**Snohomish County
Planning and Development Services**

Subject: Point Wells April 2017 Resubmittal and Preliminary Review Comments

Attachment A: Preliminary Review Comments (as of May 5, 2017)

Figure 1 – Pedestrian Access Problem to Southern Retail Building
(Adapted from Sheet A-100 [2017])

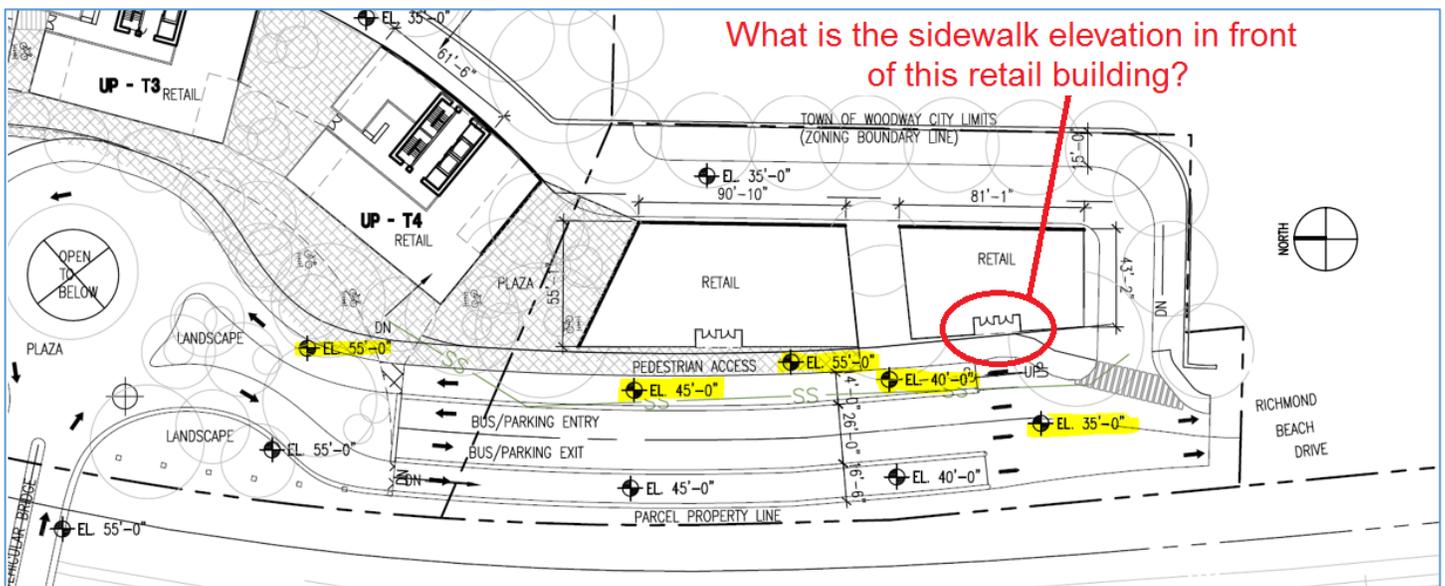
Site Plan Issue #2: If a resident wishes to walk to the southern retail building in the Urban Plaza, they will not be able to access the building entrance. As shown on Figure 1, below, the Plaza floor elevation is 55', including the elevation in front of the north retail building. The elevation at Richmond Beach Drive is 35'. The sidewalk will need to ramp up from Richmond Beach Drive to the Plaza Level. Because the south retail building sits adjacent to this ramping sidewalk, there is no way to enter the building directly from the sidewalk and no elevator entry to the building either.

Since the site plan does not provide access to the south retail building, this building cannot count as a service that would help intercept trips that would otherwise go offsite. Accordingly, the 38% internal capture rate would need downward revision. Additional issues¹ with the design of the Urban Plaza would make it impossible for us to recommend approval of this plan with a condition for a simple correction. Therefore, in a recommendation to the Hearing Examiner, PDS could not be supportive of the site plan or traffic assumptions as provided by the applicant.

Figure 2 – Central Village Area Plan with Elevators and Stairwells Highlighted (Adapted from Sheet A-102 [2017])

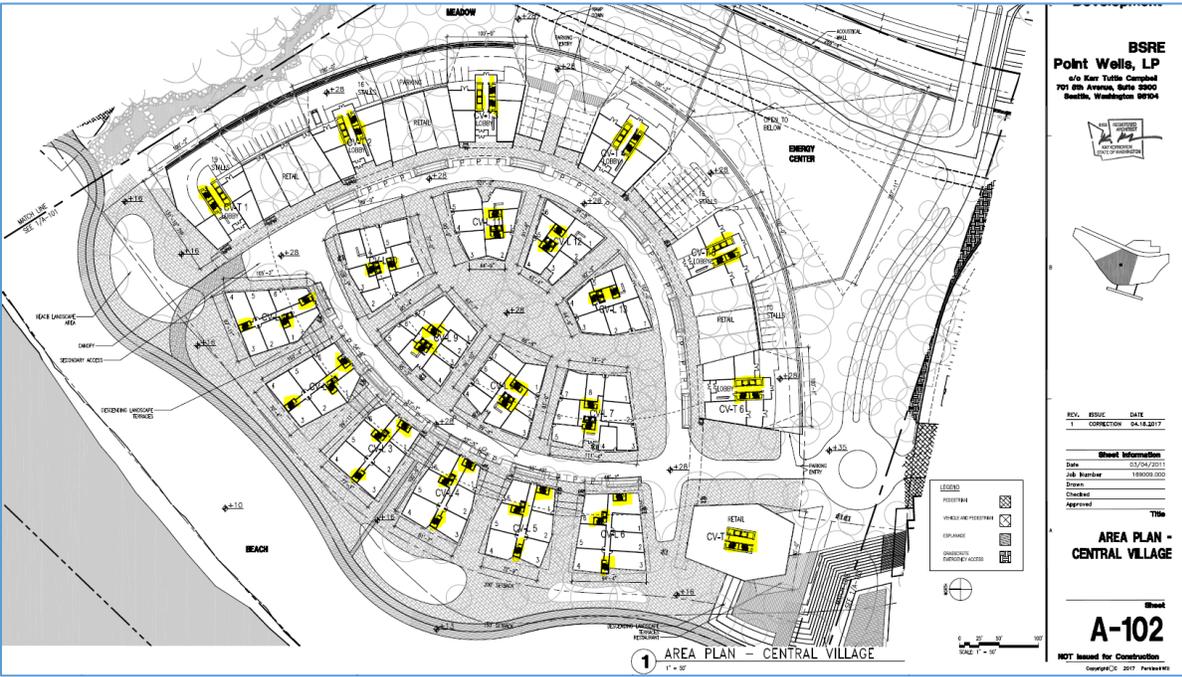
Site Plan Issue #5: There are additional problems with parking involving SCC 30.26.020 [2007]. Figure 2 highlights the locations of stairwells and elevators in the 20 buildings of the Central Village (see below). All 20 buildings are on top of a single garage.

Walking access to buildings CV-L3 and CV-L4 is more than 300 feet from the nearest tower elevator. While Sheets A-053 [2017] (not depicted here) and A-102 [2017] (Figure 2) show these buildings as having elevators, the location of elevators depicted on these sheets would include areas on Sheet A-054 (Figure 3) that are taken up by parking, the exterior wall of the garage, and underground areas outside of the garage. Therefore, we can only assume that the elevators go from ground level to the upper floors of these two buildings and that the buildings have no access to the garage.

Figure 3 – Central Village Parking Plan with Elevators and Stairs Highlighted and Approximate Location of Missing Access Points (Adapted from Sheet A-054 [2017])

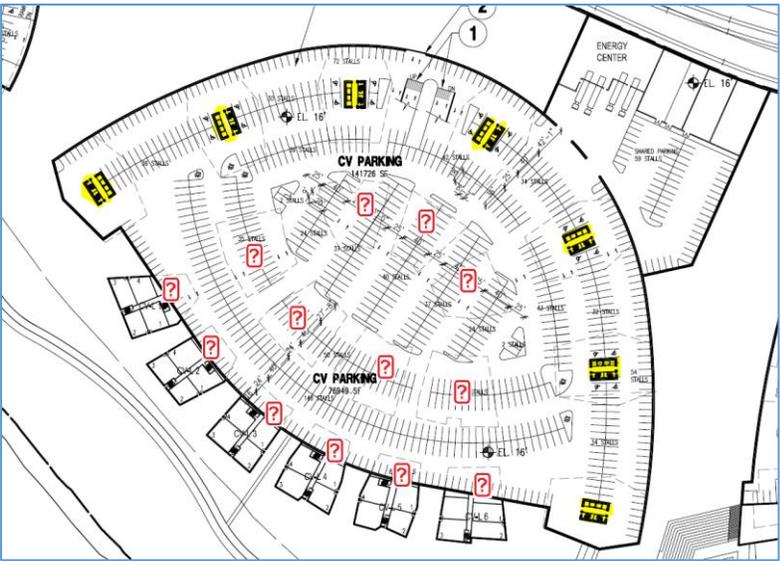
The seven tower buildings each have elevators and stairwells accessing the garage, yet none of the 13 low-rise buildings have direct garage access, see Figure 3, below. From the garage, residents of the low-rise building must take an elevator up to the ground floor of a tower building and then walk at the surface level to reach their own building.

A similar assumption applies to all of the low-rise elevators in the Central Village—they can only be above ground elevators because if these buildings were to connect down into the garage, the layout of parking and drive aisles would need complete redesign. The boxes with question marks in Figure 3 illustrate this problem. Each box represents the approximate area that providing access to the building above would be require from the garage below. Providing this direct access would impact your ability to maintain the number of required parking stalls.

Figure 4 – Stream and Wetland Buffer Impacts of Second Access Road
(Adapted from Sheet C-200 [2017])

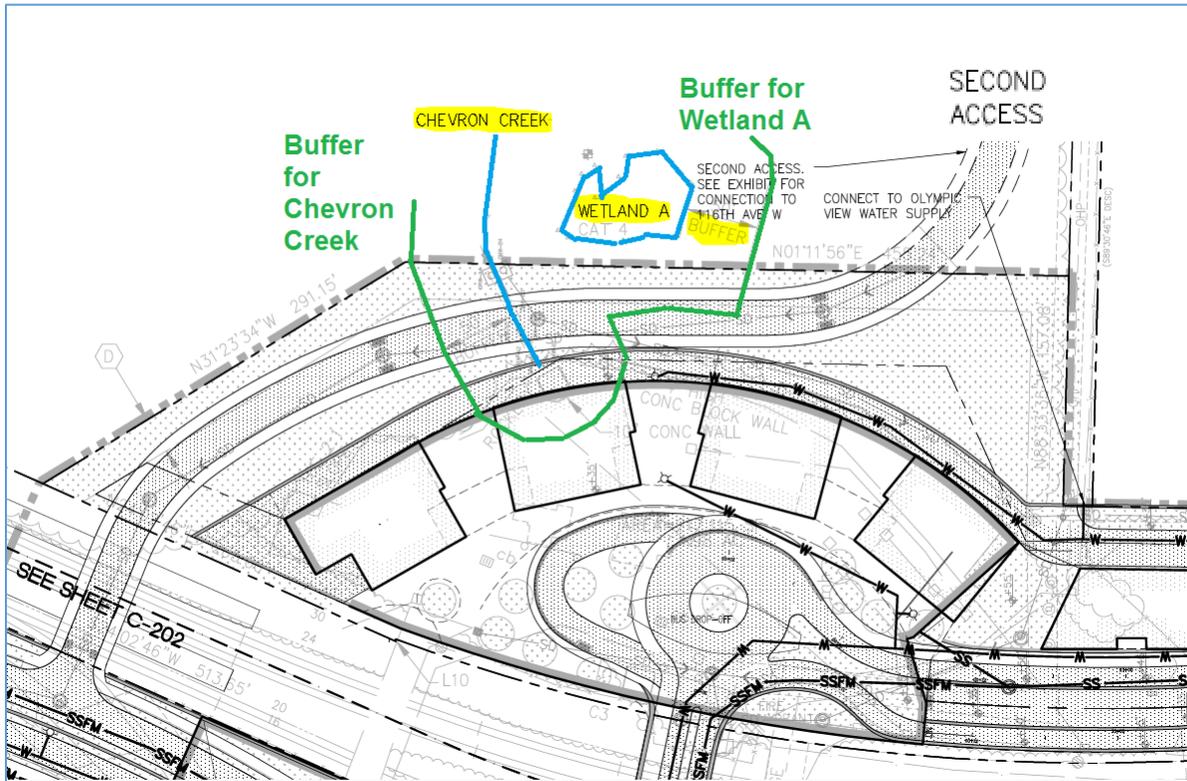
Site Plan Issue #7: A second access road appears on the revised site plan. This responds to, but may not adequately alleviate a major concern with the 2011 application, i.e. two adequate fire apparatus access roads (aka fire lanes) are required. However, the location of the second access creates at least one new problem: consistency with critical areas requirements. As shown on Figure 4, next page, the second access road would cross Chevron Creek and go through part of the buffer of a sloping wetland. Shown elsewhere, but not in Figure 4, these features are also in the landslide hazard area.

With proper mitigation and engineering, it is possible that this second access road could be acceptable. However, the request for Innovative Development Design (relief from standard critical area requirements) in the revised submittal does not adequately address these impacts. The Critical Areas Report³ and Targeted Drainage Report – both updated with the revised submittal to address other issues – both also fail in addressing issues with the second access road. There have been no updates to the Geotechnical Engineering Study since before the 2011 application. This report must address the second access road.⁴

Figure 5 – Landslide Hazard Areas Highlighted on the April 2017 Resubmittal

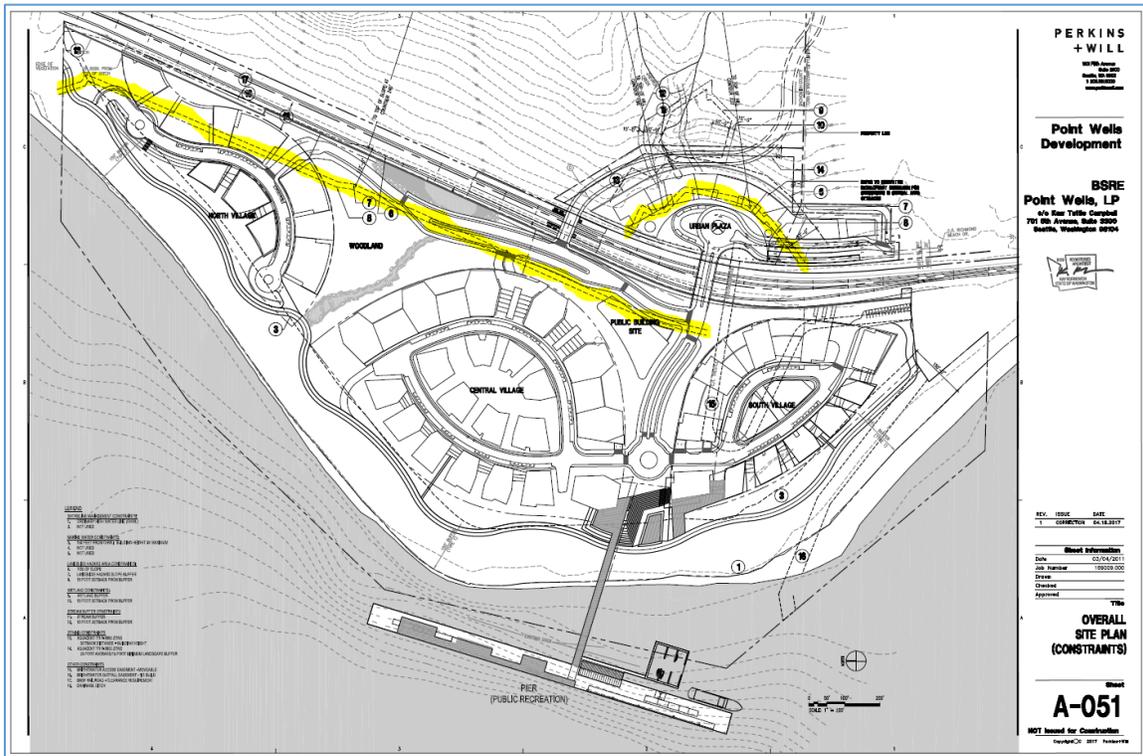
Site Plan Issue #8: The April 17, 2017 resubmittal improves on the depiction of the landslide hazard area as shown in the 2011 applications, but the new depiction is still inadequate. It adds a landslide hazard area at the Central and North Villages and does a better job of depicting the area on the Urban Plaza. Figure 5, next page, highlights these landslide hazard areas on the resubmittal. However, these lines must connect as they do on Figure 6, next page, which I emailed to you and others on your team on September 19, 2016. Note that Figure 6 was a comment on the 2011 version of the application.
